**CITY OF PORTLAND, ME  
BOCA 1999 Plan Review Record  
One and Two Family Dwelling**

Building Location: LOT #21 Alice Court CBL: 386A-B-021

Building Description: Single Family dwelling / private garage

BUILDING PERMIT REPORT LOT #21

OF:  
**LOT 21 AUBURN PINES**

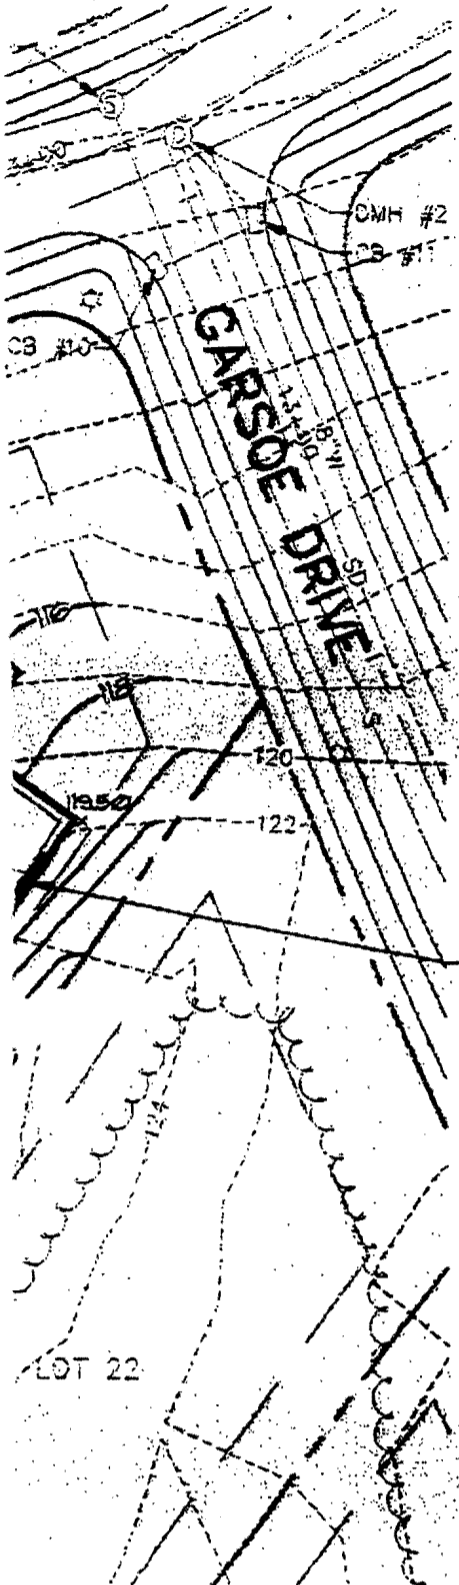
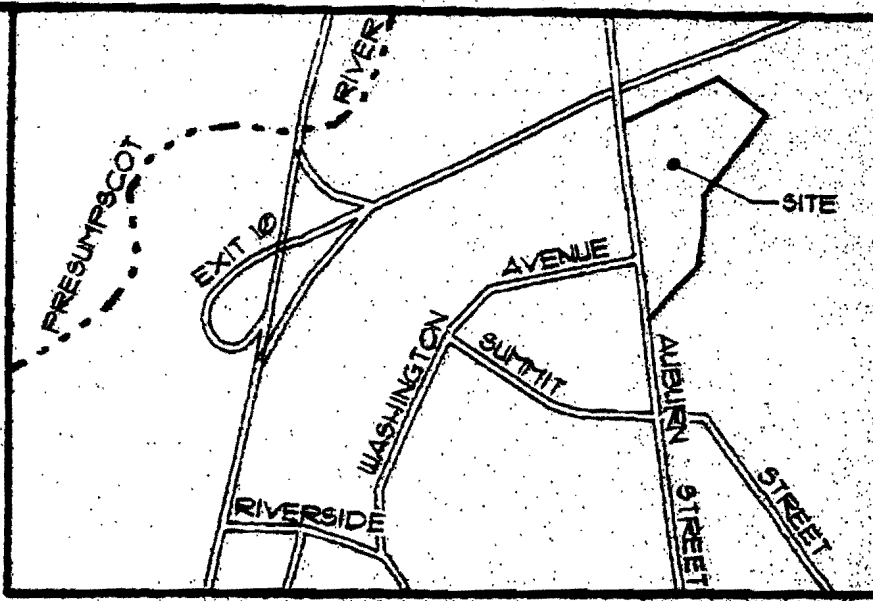
13.  Reason for Denial: The driveway slope exceeds 18% and is considered too steep. The applicant shall revise the plan to provide a driveway in accordance with the attached MDOT detail for drives on a sidewalk section. We would like to avoid anything over 18% slope.
